Case No. AA-2015-3312-PMLA
Related Case: CPC-2015-2714-VZC-SP-DRB-SPP
1029 – 1049 N. Swarthmore Avenue;
1012 – 1032 N. Swarthmore Avenue;
1023 – 1055 N. Monument Street;
15229 – 15281 W. Sunset Boulevard
Brentwood-Pacific Palisades Planning Area
Zone : C2-1VL, R3P-1VL
D.M. : 129B125, 129B129
C.D. : 11
CEQA: ENV-2015-2715-MND
Legal Description: Tract 16987, Lot 1

LETTER OF CORRECTION

REVISED LETTER OF DECISION (LOD).

PROPOSED PARCELS PLAN VIEW

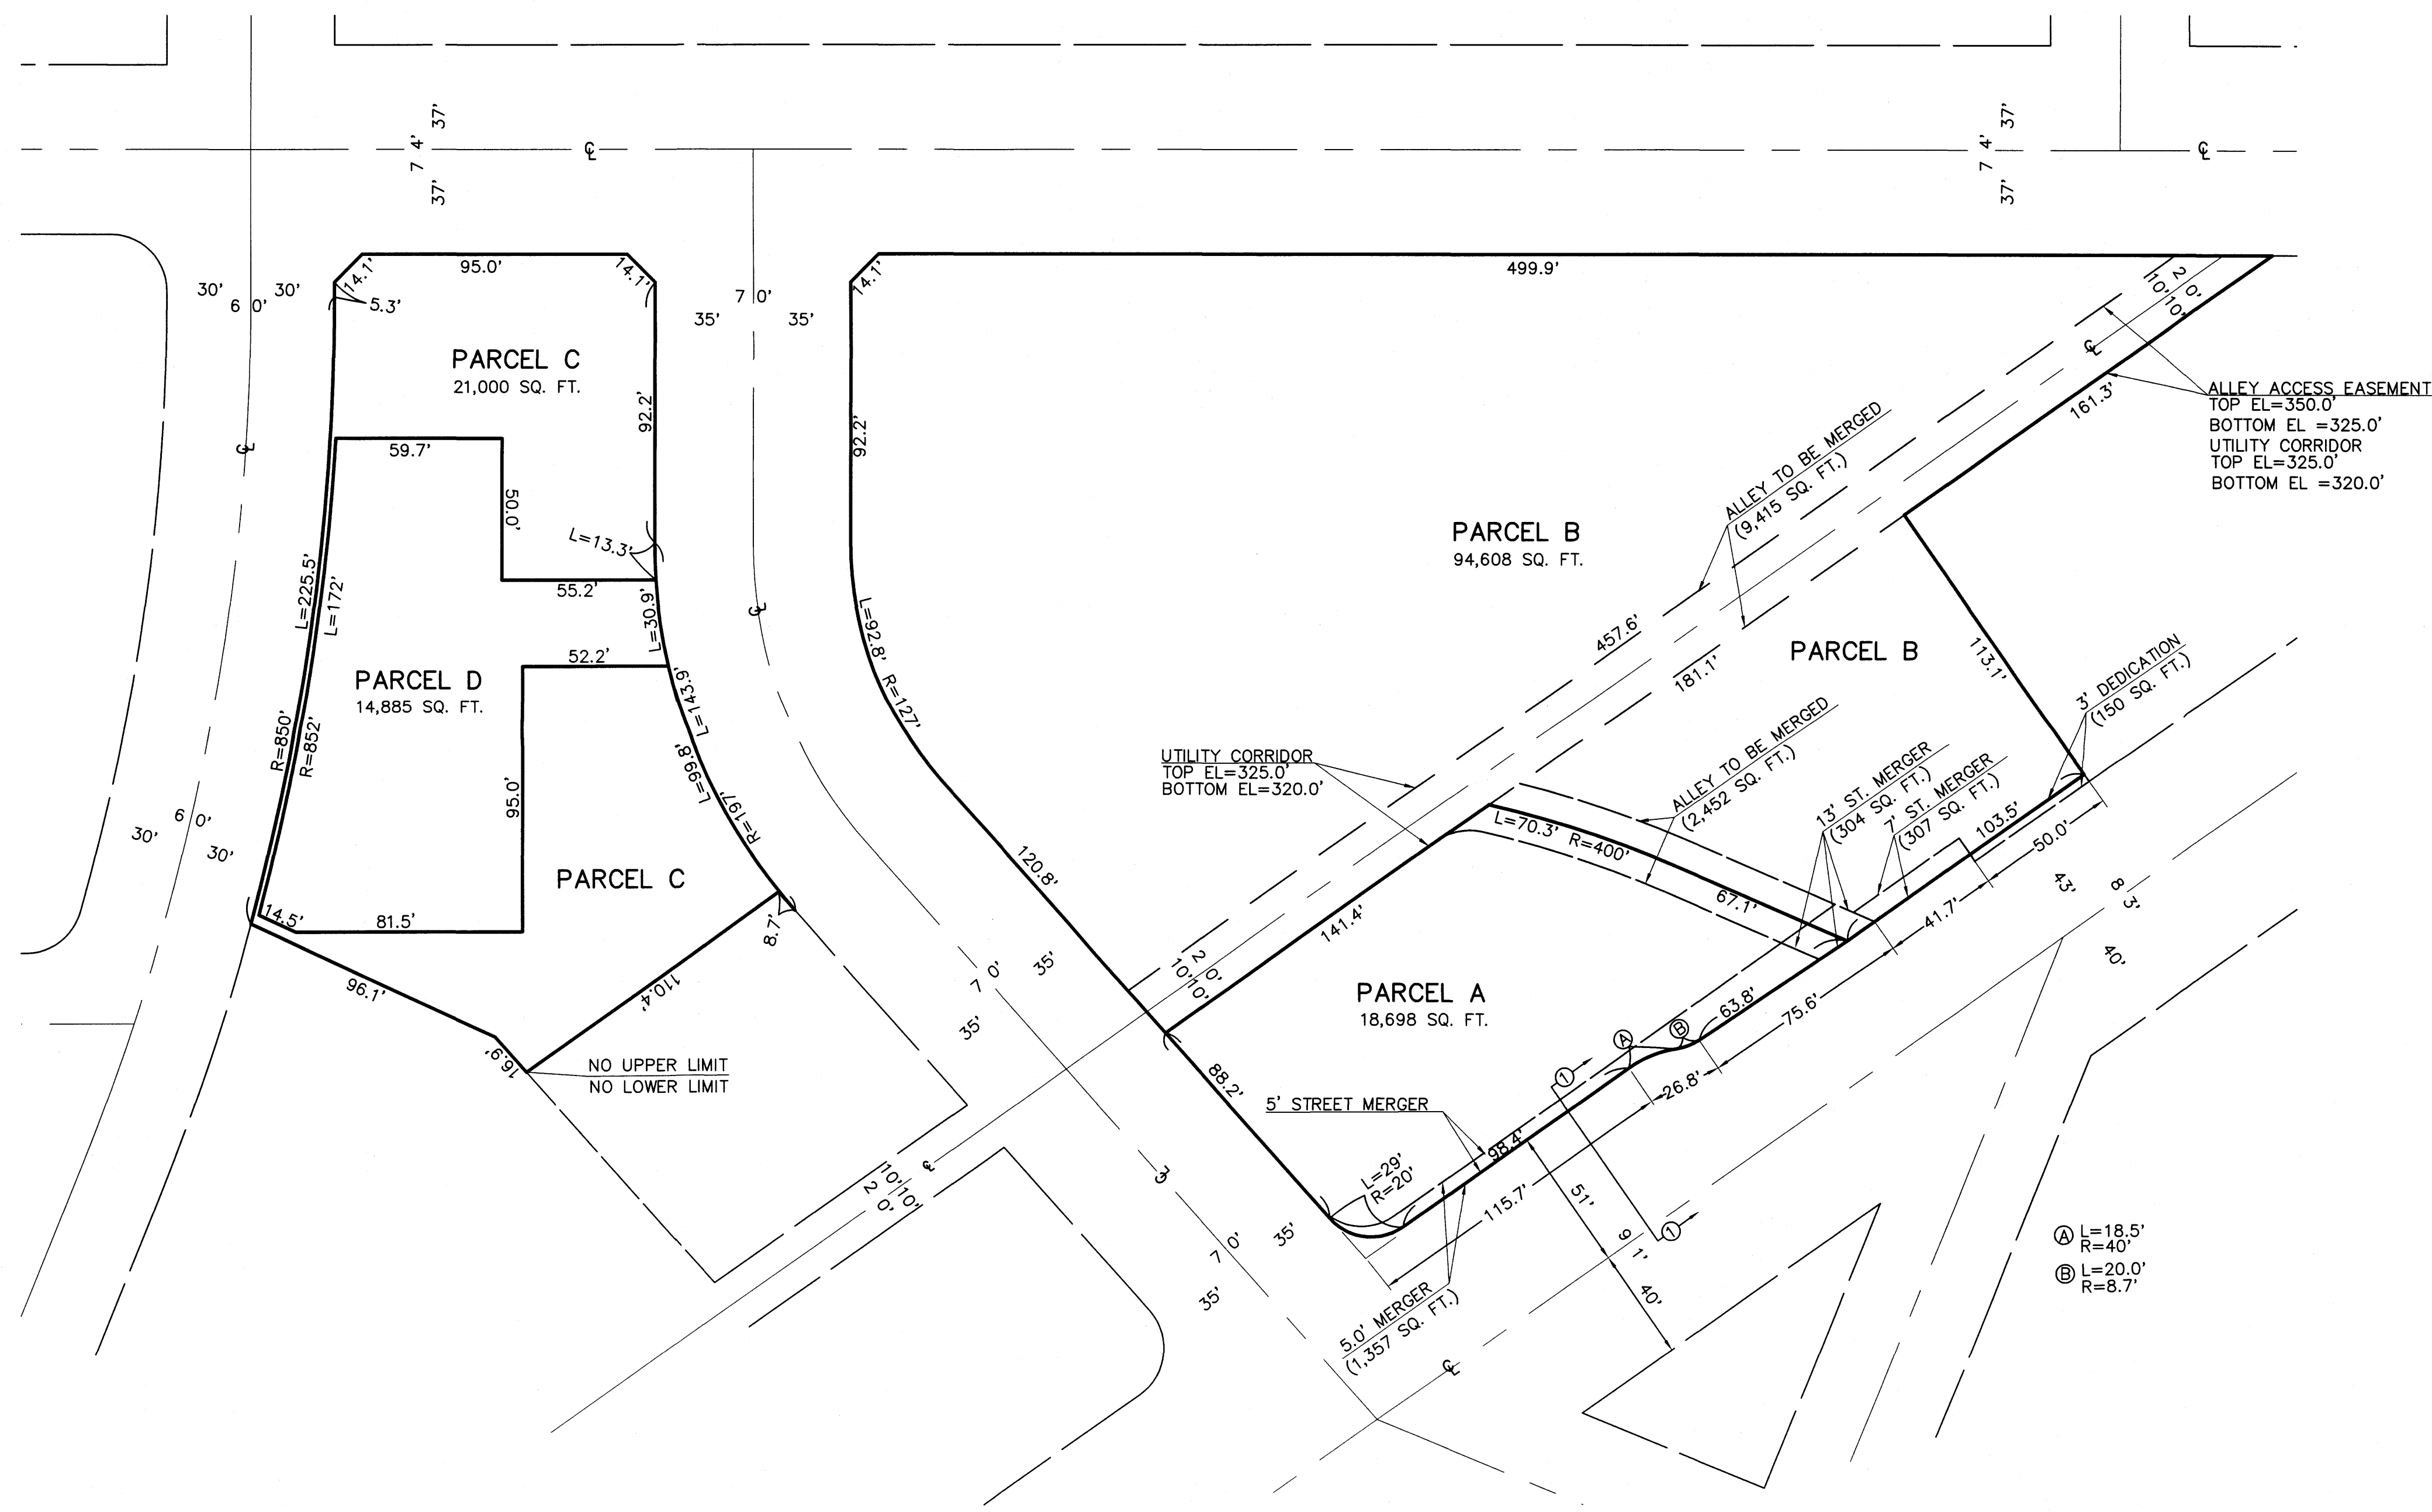
- c. Onsite parking stalls shall be designed so that a vehicle is not required to back into or out of any public street or sidewalk.
 - d. Parcel Map was revised to accommodate a right hand turn lane on Sunset Boulevard in front of the Mobil gas station onto Swarthmore Avenue. This resulted in modifying the proposed vacation/merger on Sunset Boulevard from 13 feet to 5 feet which is reflected on the revised Parcel Map.
